LINDFIELD LEARNING VILLAGE

RESPONSE TO SUBMISSIONS - BUILT HERITAGE

Figure 5 – Perforated shade structure (Cove Matt Natural colour).

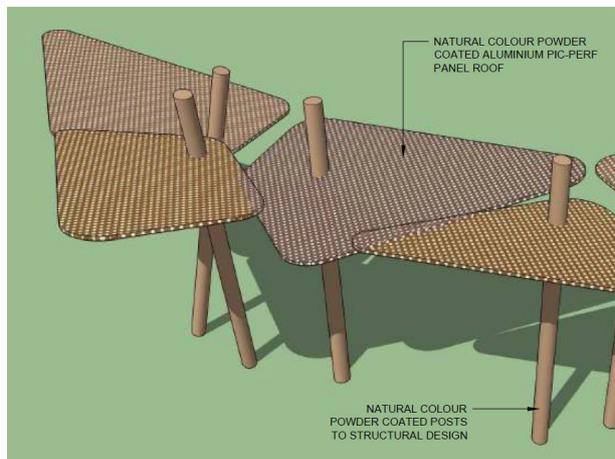
This is considered inconsistent with the landscape philosophy of Bruce Mackenzie, the original landscape architect, that maintained, 'existing contours, rocks and trees can be the main determinants of composition', emphasising the importance of the 'often-subtle juxtapositions between built elements and soft landscaping and remnant bushland on the site' (CityPlan Heritage 2004).

- ***It is recommended that as for Phase 1, a condition of consent be include requiring that the landscape works in the southern section of the site be finalised in consultation with Bruce Mackenzie to ensure a sympathetic approach in accordance with the landscape philosophy.***

Please refer to a selection of precedent images below which indicates the intended organic nature of the landscaping (including shade structures).

Figure 7 View towards new opening from Level 4 entry showing 50% reduced size of opening.

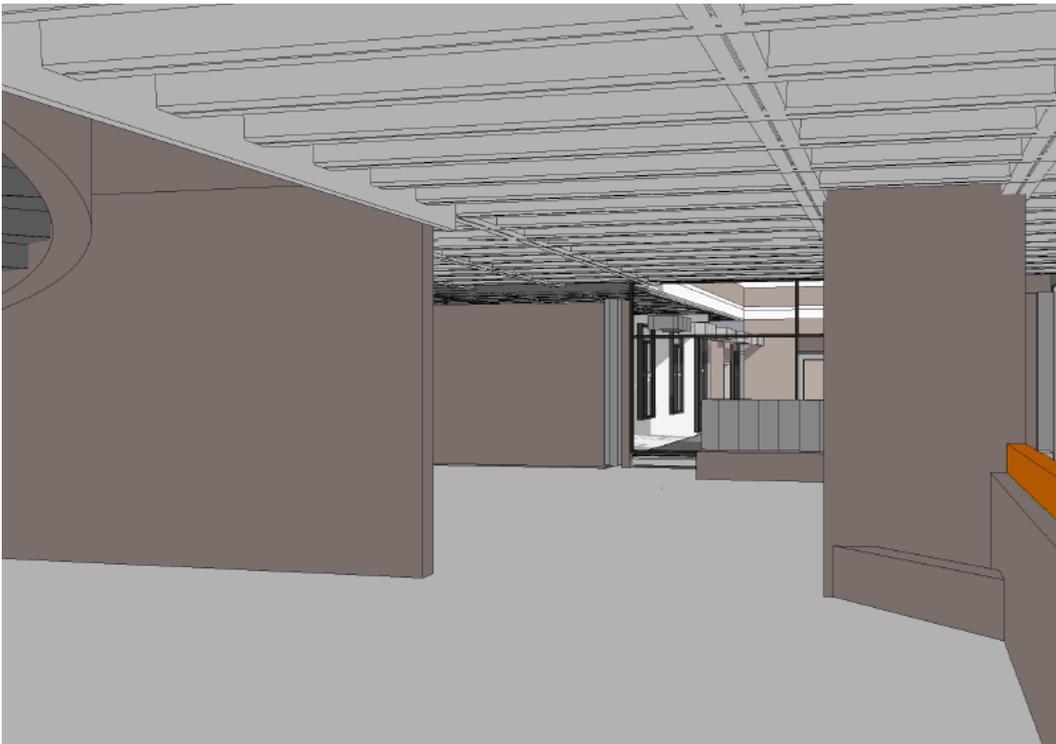
The proposed removal of two portions of concrete wall (3853mm wide and 3376mm wide x 2700mm high) for increased light penetration will require the removal of a substantial amount of original fabric, identified in the CMP as of high significance. The removal of a substantial area of the existing concrete wall adjacent to the spiral stair will have an irreversible physical and visual impact on the significance of the item.

- It is recommended that a condition of consent be included requiring that an alternative light source is designed to ensure significant fabric and views are preserved intact.

The design of the proposed opening through the concrete wall adjacent to the spiral stairs near Level 4 entrance to Stage 2 has been amended. The extent of the opening has been reduced by 50%. The area immediately adjacent to the staircase would be retained in its entirety and the opening to achieve light penetration through the building would be confined to the area to the north.

Figure 8 Proposed bus turnaround area.

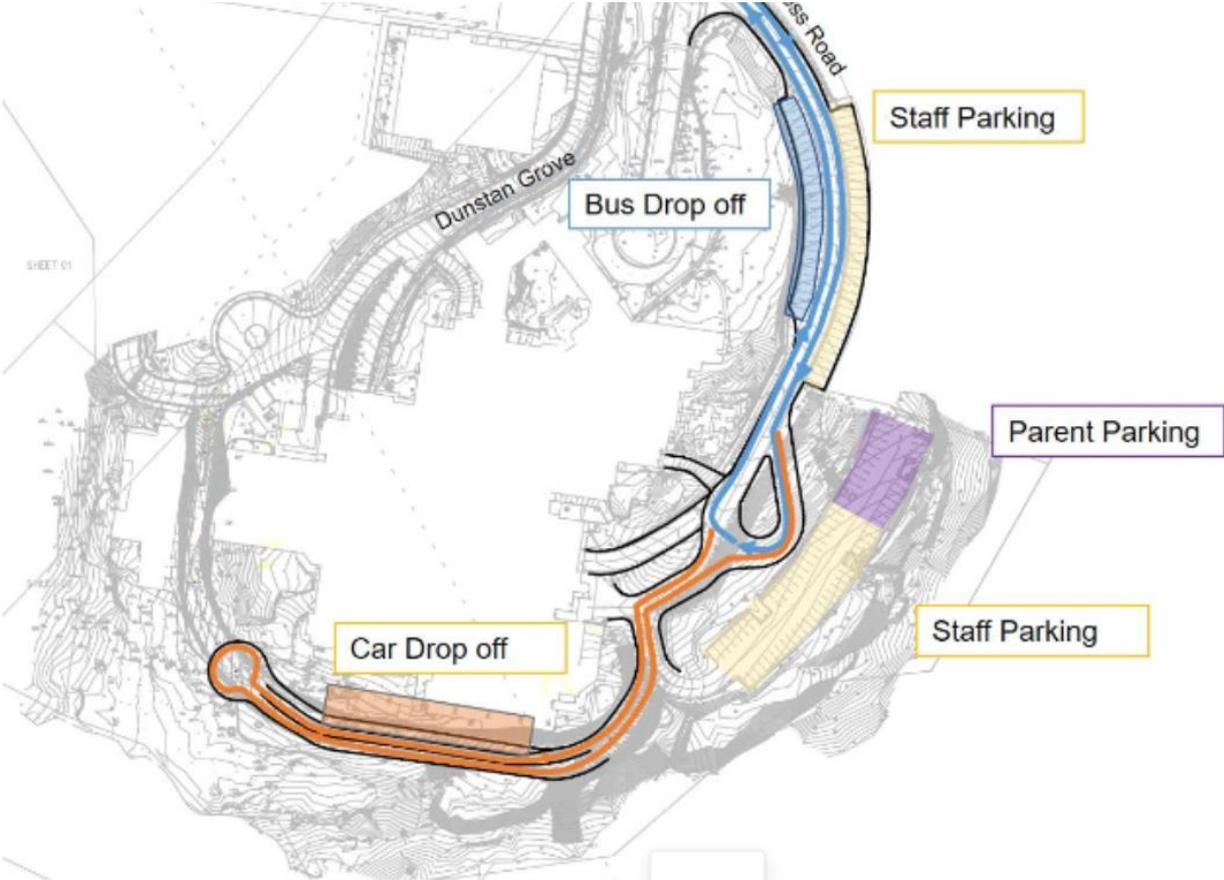
In terms of heritage impact the loop road is not supported as the preferred solution. While the loss of trees is low, the continued incremental loss, first from the APZ and now to build the road, is creating a denuded space in the landscaped area closest to the southern façade. This will have a detrimental impact on the setting. The relationship between the campus building and the immediate landscape is a key element of the original design. The “brutalism” is moderated by the way in which the College was designed to respond to the topography and bushland setting of the site.

This assessment lacks an analysis of where these trees are sited and the localised impact of their loss as opposed to a numerical assessment of the total loss of trees for the total site. The clearance of the inner ring closest to the building has already been severe.

The proposal has been revised to incorporate a driveway extension (in place of the Loop Road). This option proposes a wider road and turning circle as shown in the image below. It is acknowledged that this is located directly in front of a distinctive façade of the building While option 1 also requires this separation, it is considered to be more pronounced in option 2 given it would be a two-lane road. It would not however have a detrimental impact on carpark 1 or 2 (note that Carpark 1 is of moderate significance). It would further have no impact on the Dunstan Grove Road Cutting or the form of the main entrance original vehicle drop off.

It is acknowledged that the bus loop to the east of the building would require a substantial cantilevered road. As outlined above it is proposed to screen the underside of the road / engineering supports to the new cantilevered road with groups of 20 or so tensioned vertical cables at 4-8m centres for climbing plants. To achieve appropriate growing conditions for the climbers it is proposed to install a circular terraced garden bed (or multiple beds) at the base of the slope and to the radius of the road above. Further pockets/groups of planting will be proposed within the void (teardrop shape) and in accordance with the bushfire conditions. Although there are no significant views identified from the lower carpark (which was a post 1985 Stage 6 addition to the site) this would assist in visually incorporating the new structures into the landscape.

Figure 11 View towards new opening from Level 4 entry showing 50% reduced size of opening.

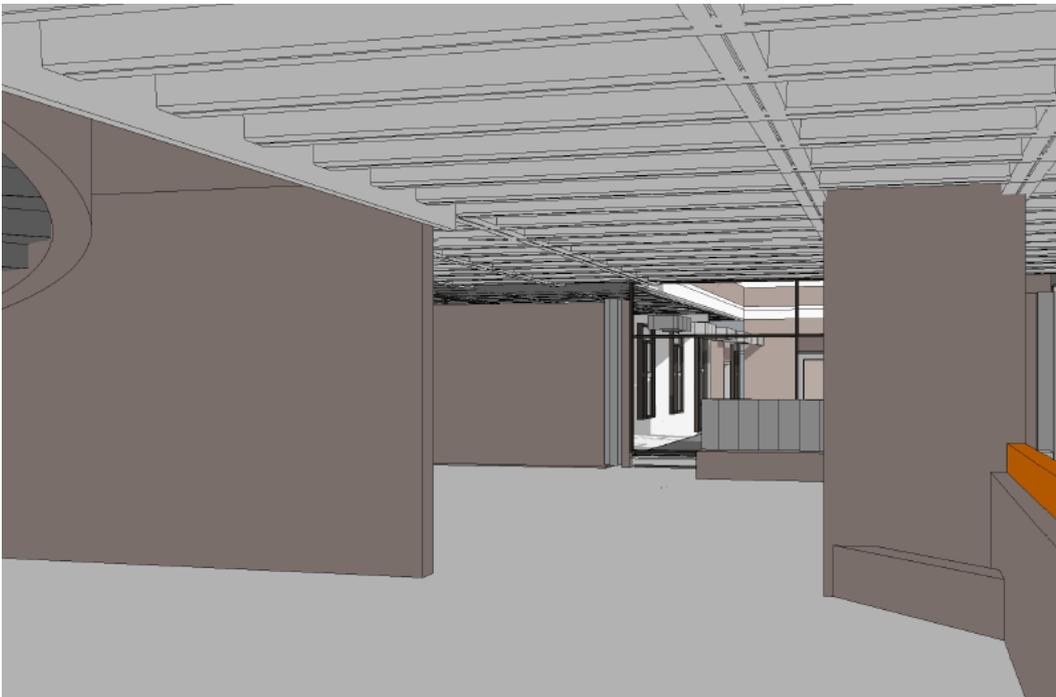
The removal or “penetration” of this wall is not supported. From the images it appears to be off form and concrete wall. The concrete walls are original fabric of exceptional significance. Much of the interior is being removed to allow the site to function as primary and secondary educational facility. The unnecessary and seemingly optional removal of this wall so close to such a significant element being the spiral staircase cannot be supported. Alternative solutions to provide light should be explored and the wall retained. A secondary option would be the use of a high-light window which will allow light but keep most of the wall intact as opposed to such an excessive and generous opening.

The design of the proposed opening through the concrete wall adjacent to the spiral stairs near Level 4 entrance to Stage 2 has been altered. The extent of the opening has been reduced by 50%. The area immediately adjacent to the staircase would be retained in its entirety and the opening to achieve light penetration through the building would be confined to the area to the north.
